INDESIT company

Model type:
ARTXF109EU

Commercial code:
F060606

1260310 Exploded views

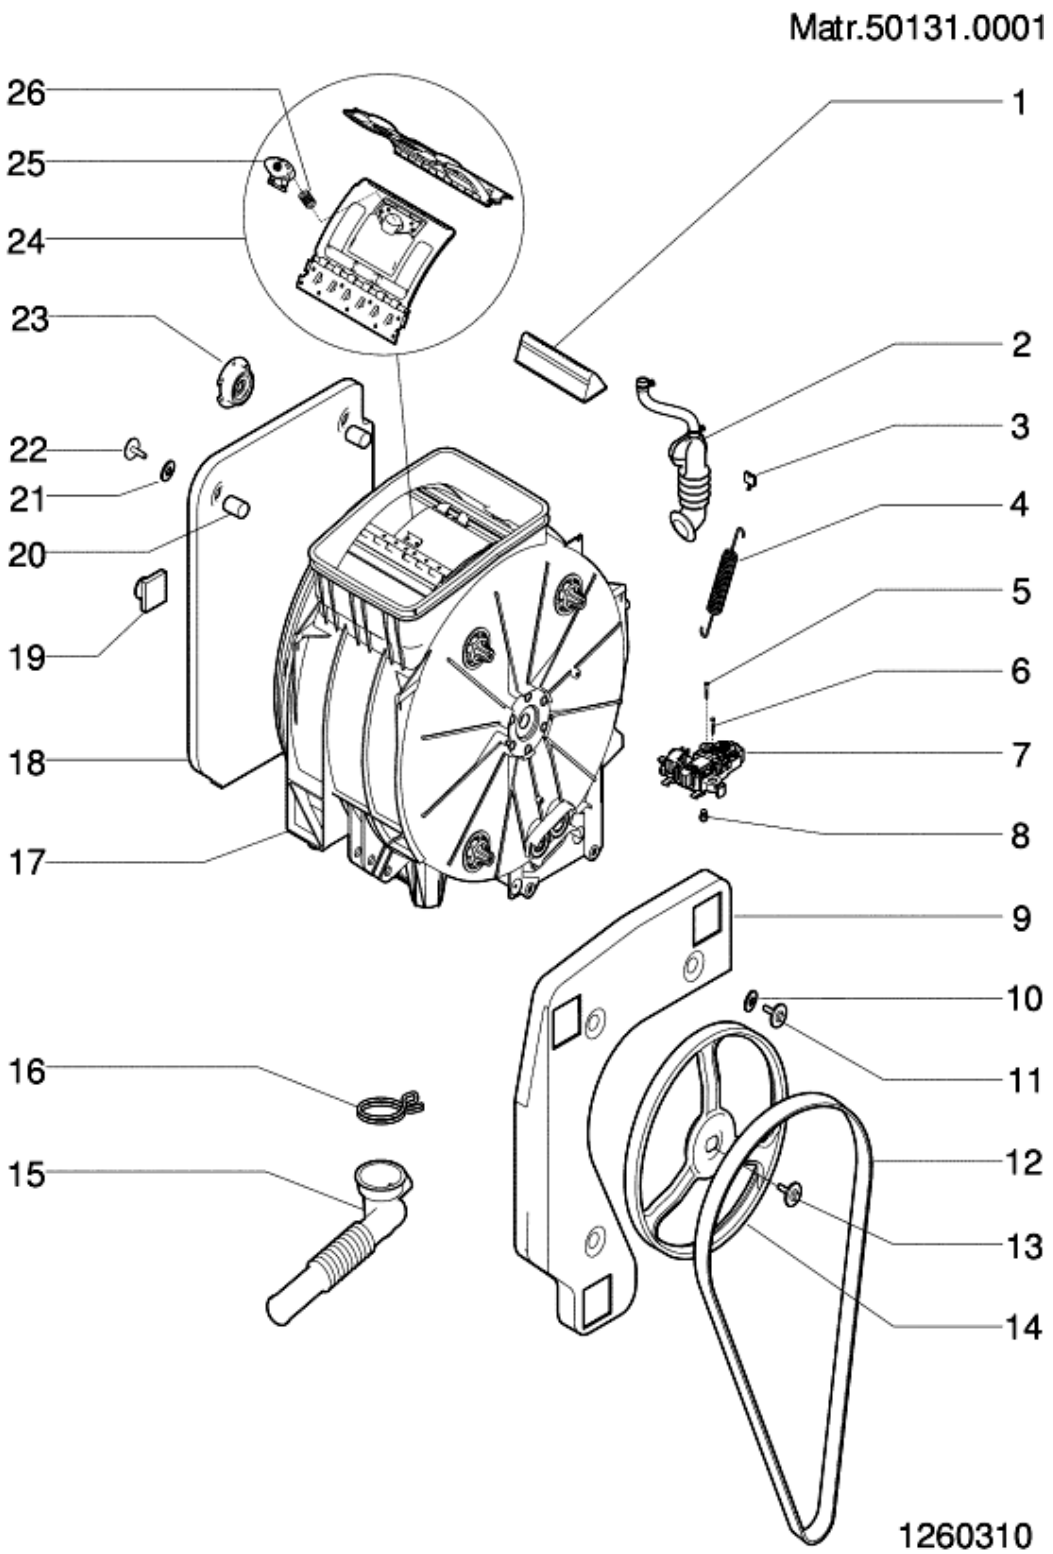
n4009a02: Motor fixing changed on Top Loading washing machines

Top Loading washing machines have changed the fix of motor to the tub.
The tub design is changed in the motor fixing side and two new screws code C00268497 are introduced instead of the old screws C00084333 and the old nut:

C00266015 nut of products with Triphase motor;

C00258673 nut of products with Collector motor.

Spare parts warehouse will go on to manage only the new tubs with the same spare part codes:

C00111505 - Tub 600/1000 rpm

In assistance on premodification products with the new tubs, you have to fix the motor using the new screws C00268497 instead of the screws and nut that you find in the product.
